6626A-11

S E R V I C E N O T E

6626A DC Power Supply

Intermittent Power Transformer “Magma” Connections

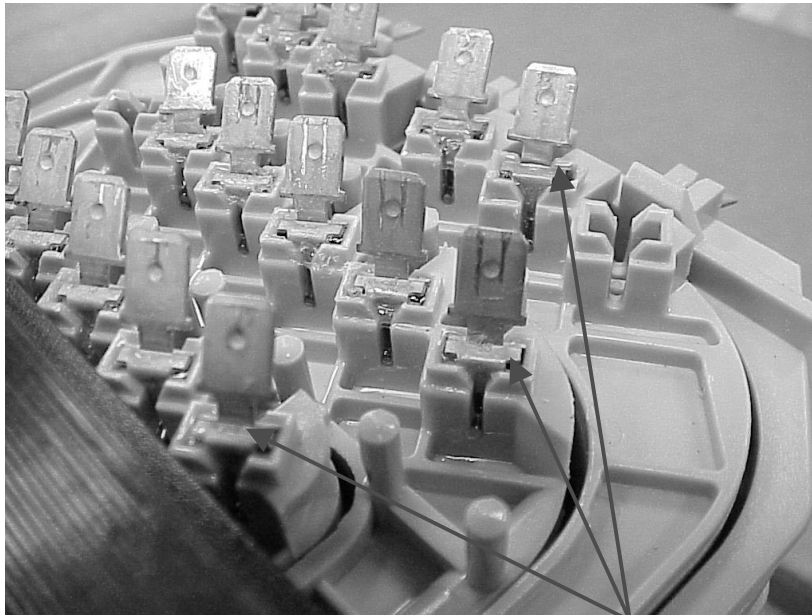
The power transformer vendor mistakenly installed the wrong “Magmates” in a run of power transformers. The incorrect “Magmates” have a # 43 stamped on them, which corresponds to a 15 gauge wire size. The correct size “Magmate” should be # 24 designed for a 19 gauge wire size.

This could result in a variety of intermittent as well as steady hardware problems and errors. Examples: HDW ERR CH 1, Blank front panel display, not meeting specifications.

Replace the Power Transformer with a new replacement Transformer, see the table above for the correct power transformer part number.

NOTE: Please inspect the new transformer for the correct “Magmate” number stamping.

Top View of Power Transformer:

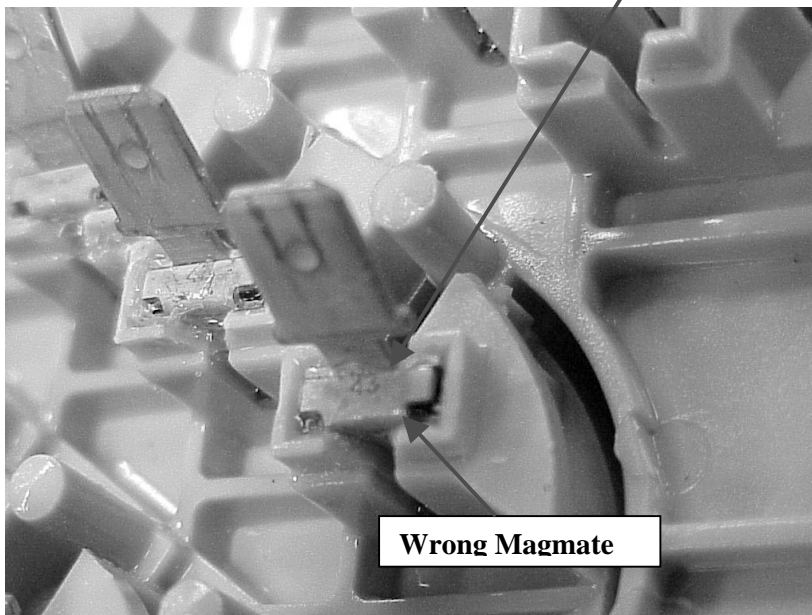
Incorrect “Magmate” number 43 on the Surface, This should be number

Wrong Magmate
